REF: El Jardin Office Building (H22-D29)

PROJECT: *El Jardin Office Building
Modified Drainage Plan.*

Subject: Drainage Correction for El Jardin Office Building

CULVERT DRAINAGE - SECTION

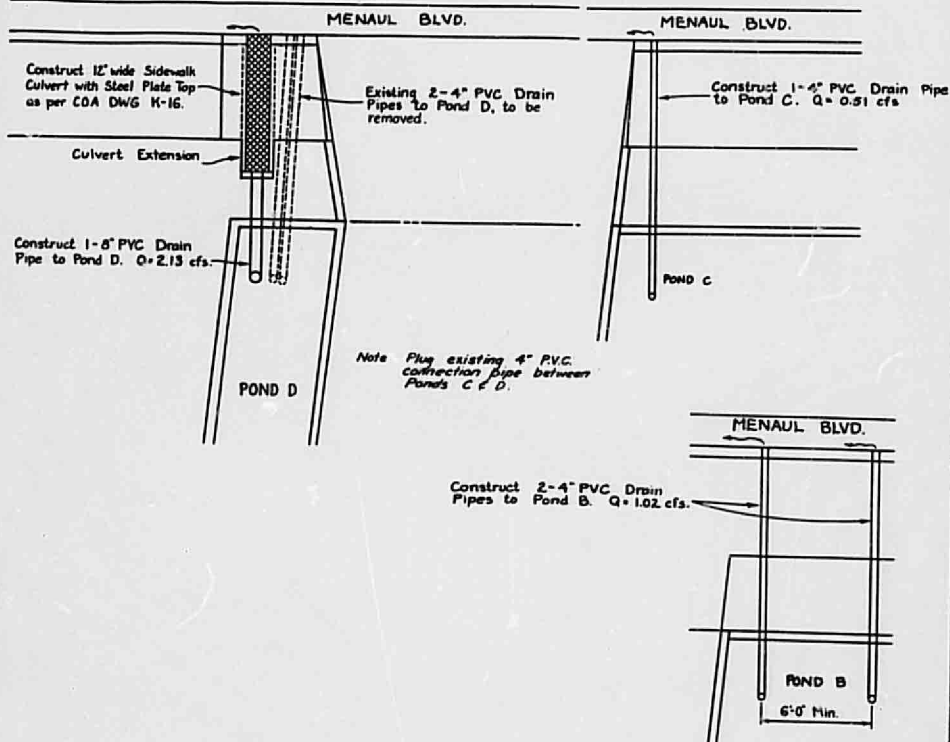
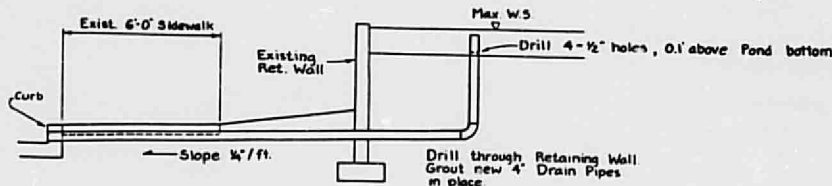
As per our telephone conversation the size of the pipes were changed from 6" PVC to 4" PVC as proposed in my letter to you dated 4/12/83. Due to this change in pipe sizes, the total discharge will now be 3.57 cfs instead of 3.84 previously stated in that letter.

The new discharge rate is to be accomplished by adding 1 - 6 inch outlet pipe from the northwest corner of Pond B to Menaul with a maximum discharge of 1.16 cfs; adding 1 - 4 inch outlet pipe from the northwest corner of Pond C to Menaul with a maximum discharge of 0.5 cfs; plugging the outlet between Ponds C and D and adding 1 - 6 inch outlet pipe to the existing 2 - 4 inch pipe from Pond D for a total maximum discharge of 2.18 cfs.
